APPROVAL HISTORY

PROPOSED MODIFICATIONS

3. UPPER ROOF RAILING HEIGHT MODIFICATION.

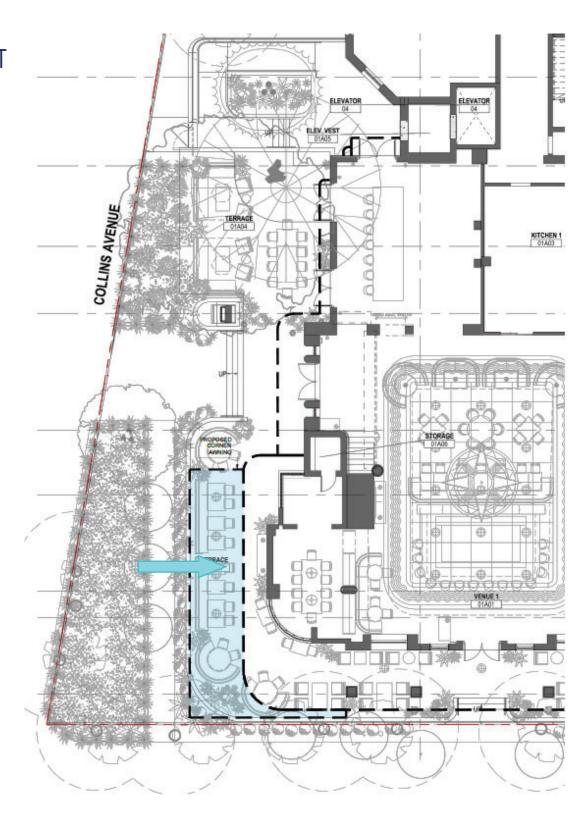
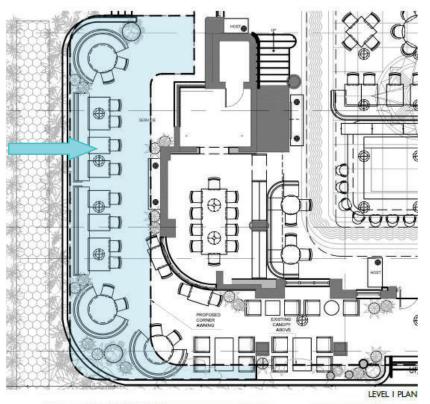
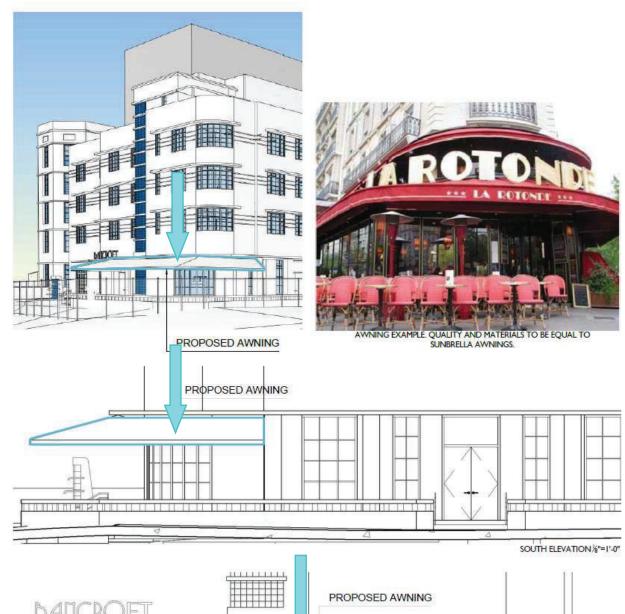
Add one course of CMU blocks and cable rail.

8. HISTORIC LOBBY. Addition of bar.

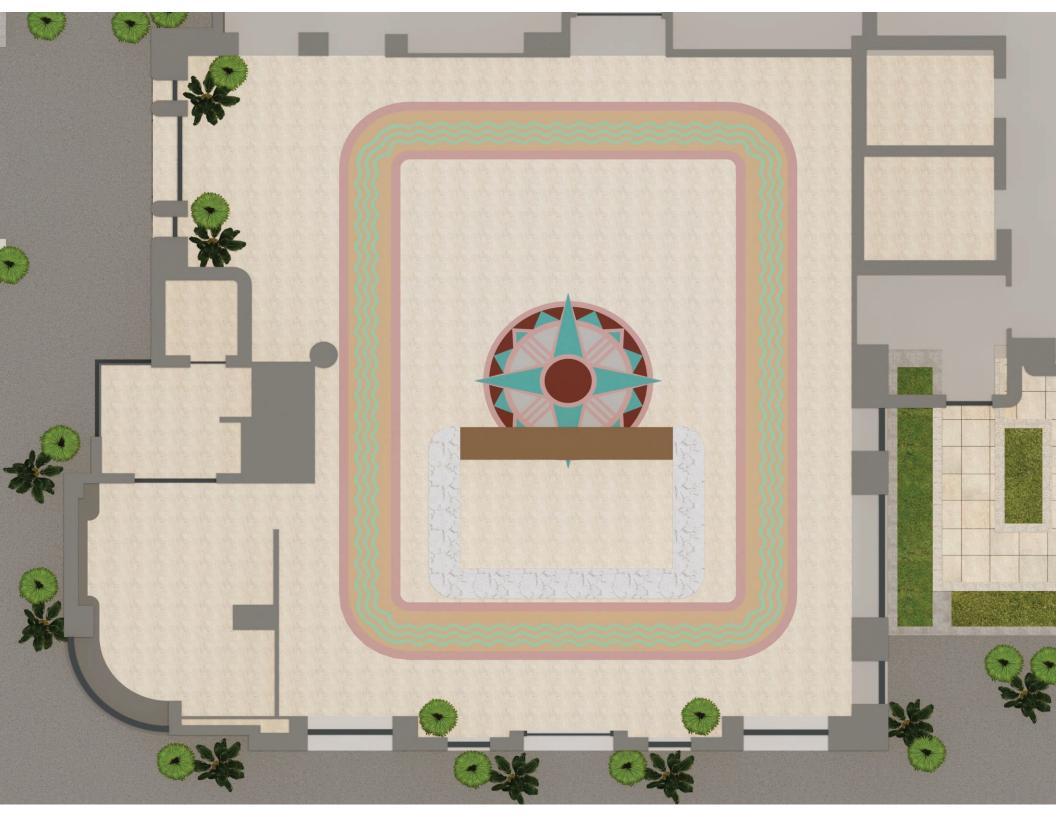
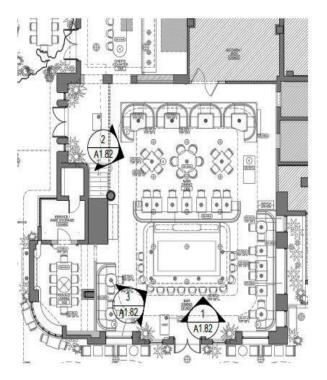
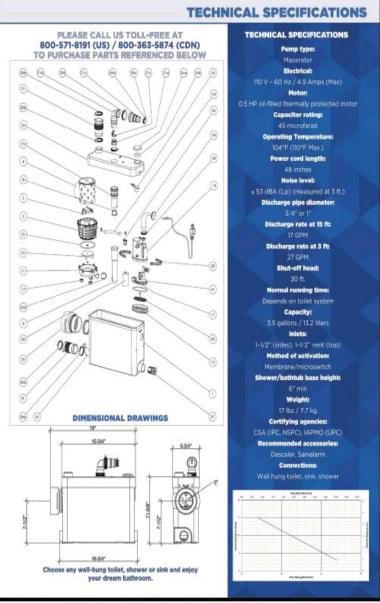
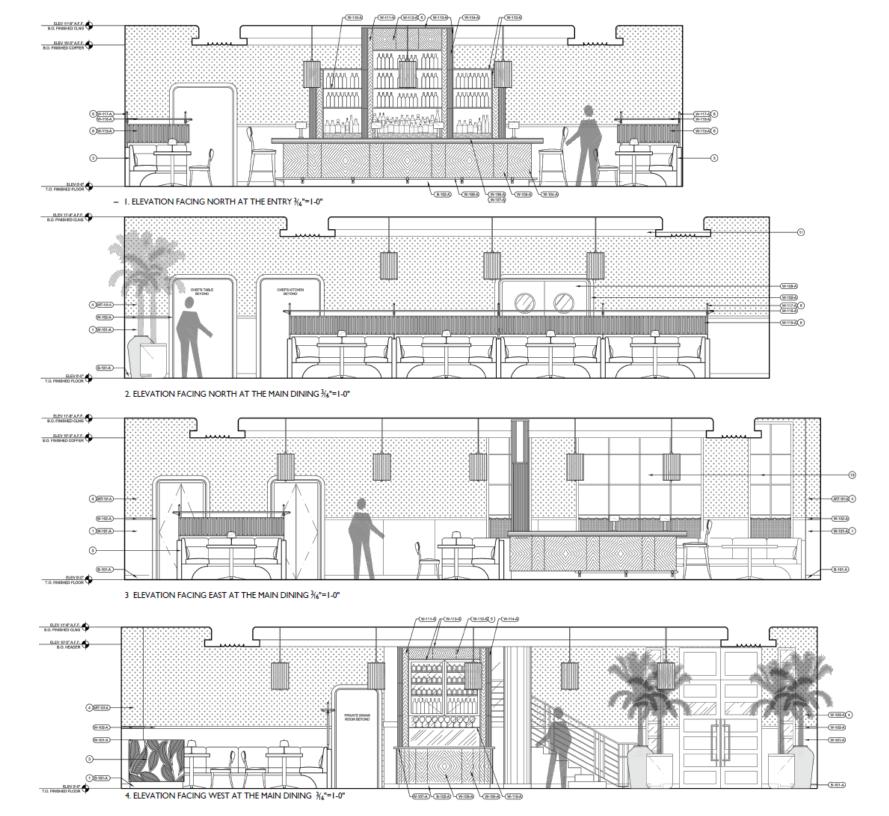
BAR EQUIPMENT- POTENTIAL LOCATIONS OF SANIFLOW SYSTEM TO AVOID PENETRATING EXISTING FLOOR

PROPOSED PLUMBING EQUIPMENT TO AVOID PENETRATING EXISTING FLOOR TO BE USED AT BAR

9. 3RD LEVEL EAST FAÇADE.
ADDITION OF GLASS BLOCK.

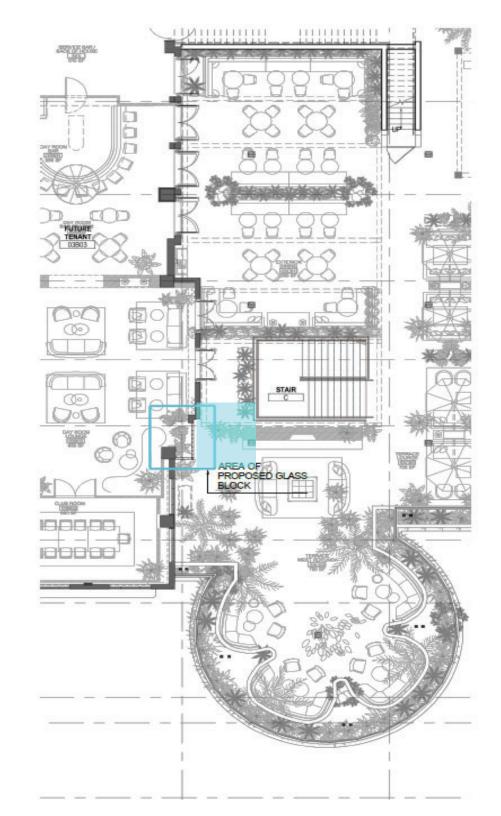
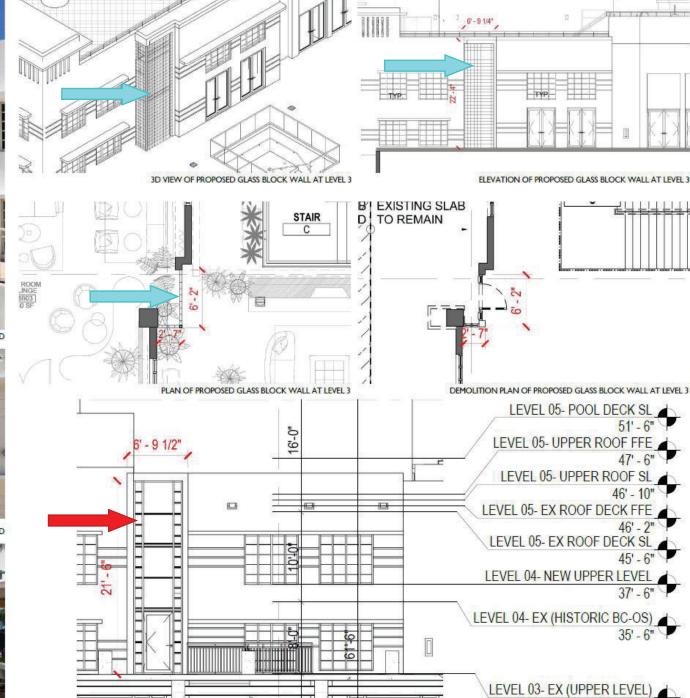
DEMOLITION ELEVATION OF PROPOSED GLASS BLOCK WALL AT LEVEL 3
